## NV15, 1/2MX32 DDR, RGB, TV\_OUT, VIDEO\_IN, AGP4X.

## Design Notes:

Λ.		Micro-Star International Co., LTD.	
	MSI		MS-8820	
		Size	Document Number	Rev
	<b>V</b>	В	Based on P-22-B00	1.0
	•	Date:	Tuesday, May 15, 2001 Sheet 1 of	18

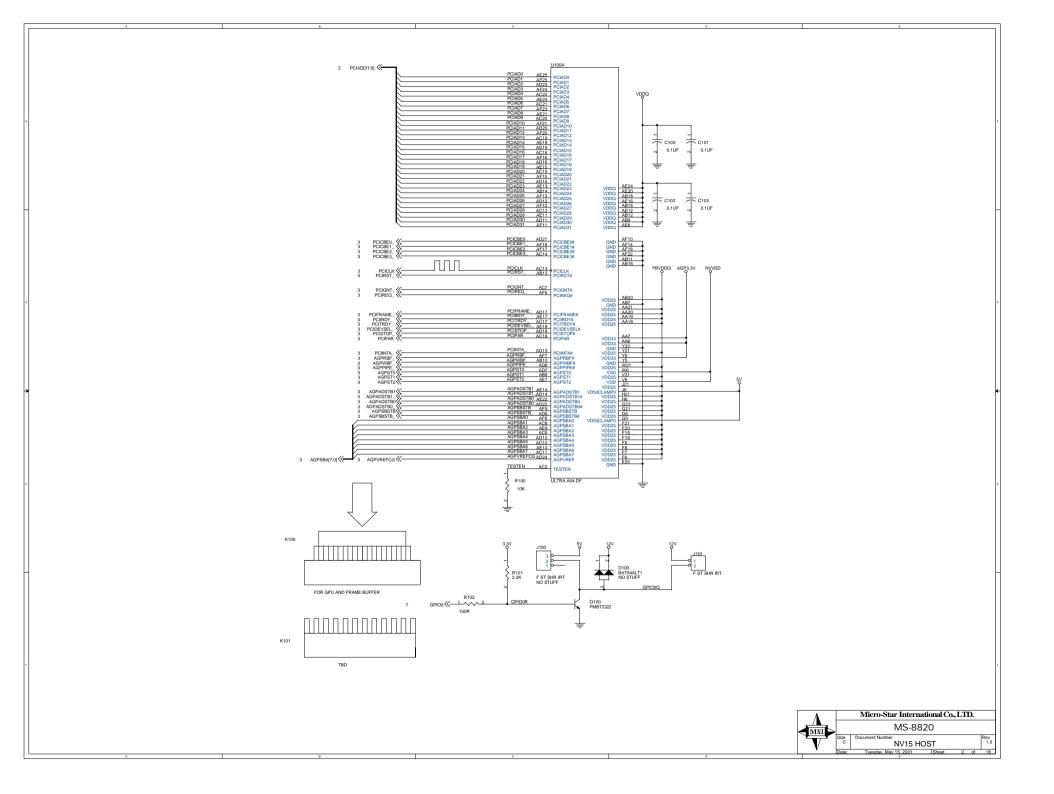
B00:FIXED TMDS CLKs CONNECTIONS.

B00:ADDED 4MX32 SUPPORT.

B00:Corrected memory configuration resistors.

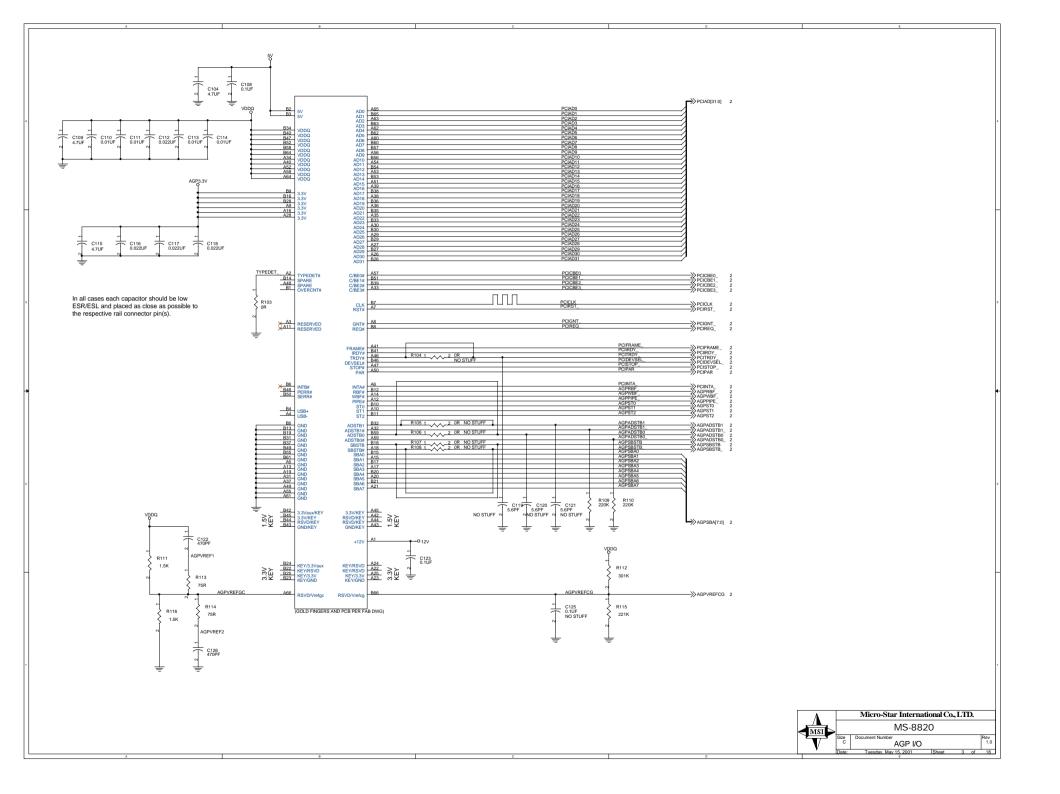
B00:Changed C809 to 4.7UF.

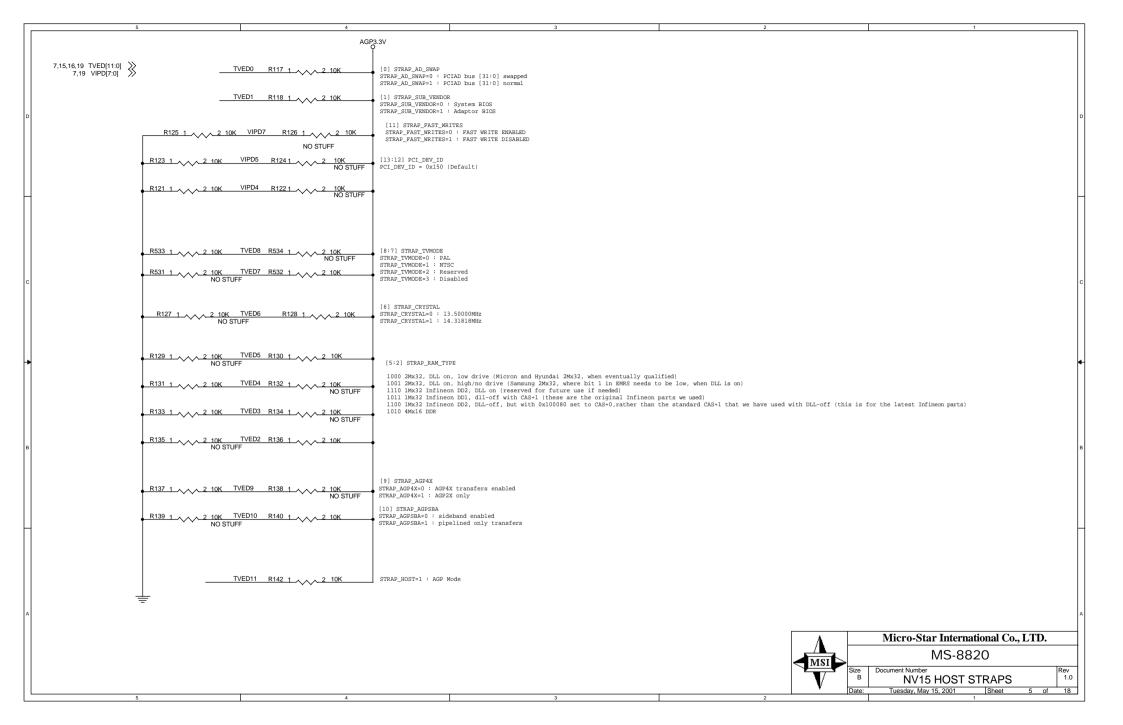
B00: Changed R811 from 100R to 105R

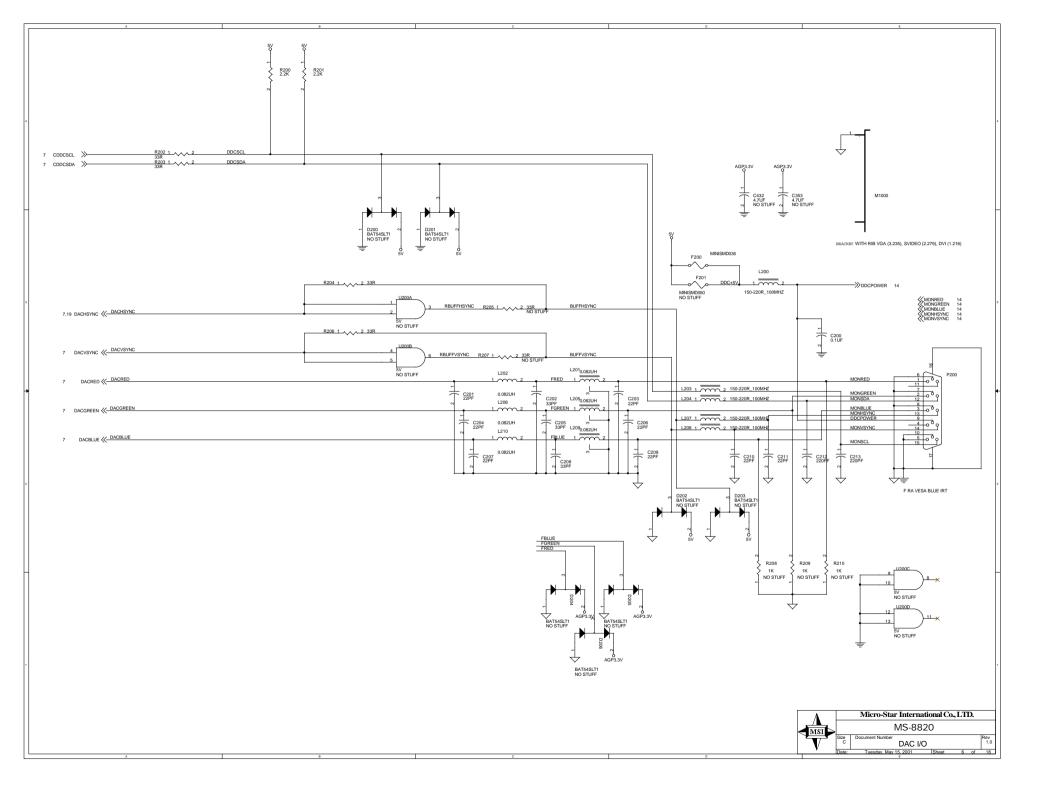
B00:C128 changed to no stuff

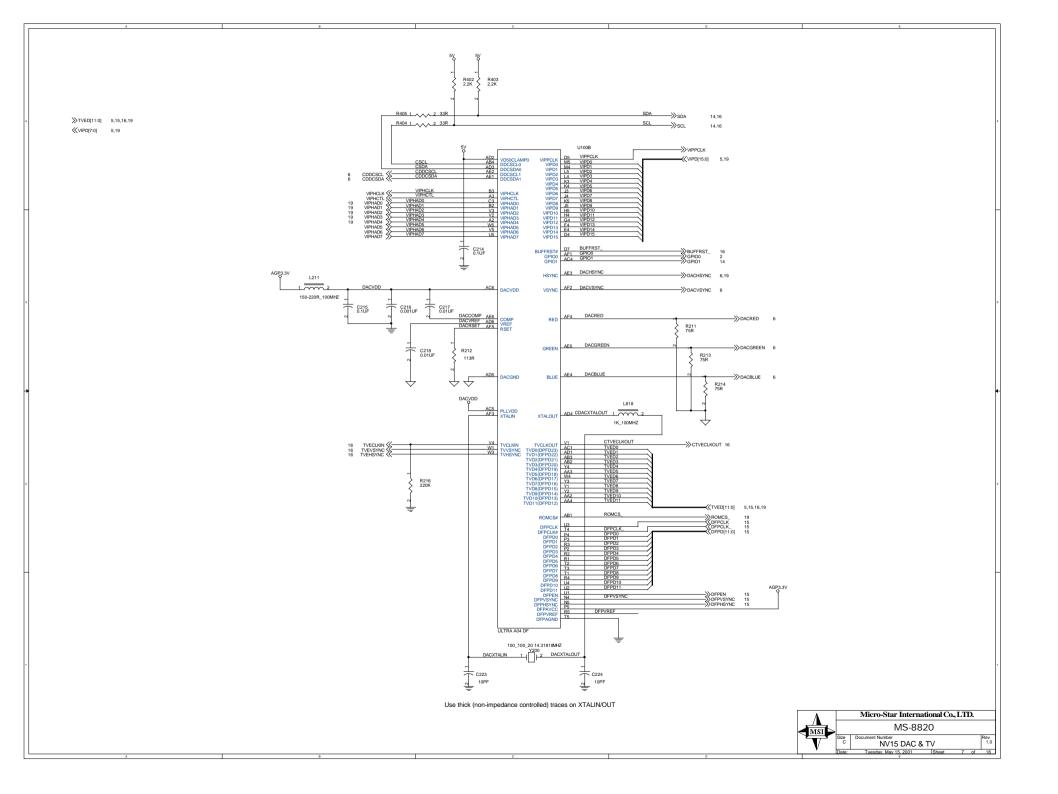
B00:Removed 4mx32 function (R876, R877= NO STUFF)
